FACILITY COMPLIANCE INSPECTION REPORT
Division of Waste Management
Solid Waste Section

Date of Site Inspection: July 26, 2013

Edgecombe Co. MSWLF Transfer
 2797 Colonial Road
 Tarboro, North Carolina 27886

Comprehensive Audit

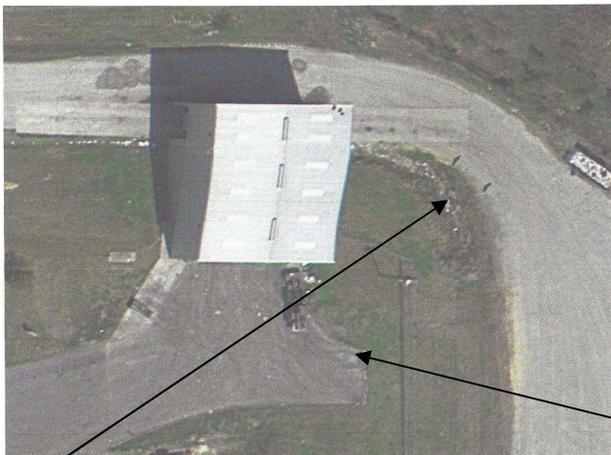
Grate for drain from turn ramp. Trash and anything that falls on the ramp is washed toward the grate conveyed down a pipe and onto the ditch around the base of the transfer building. A method needs to be found to screen runoff so waste is not washed down the grate or into the ditch.

The wind fence on the eastern side of the building needs to be extended to the building wall.

Location of the grate draining the haul ramp
The area to the east of the facility has problems with trash being washed and blown down into the ditch on the eastern side of the property.
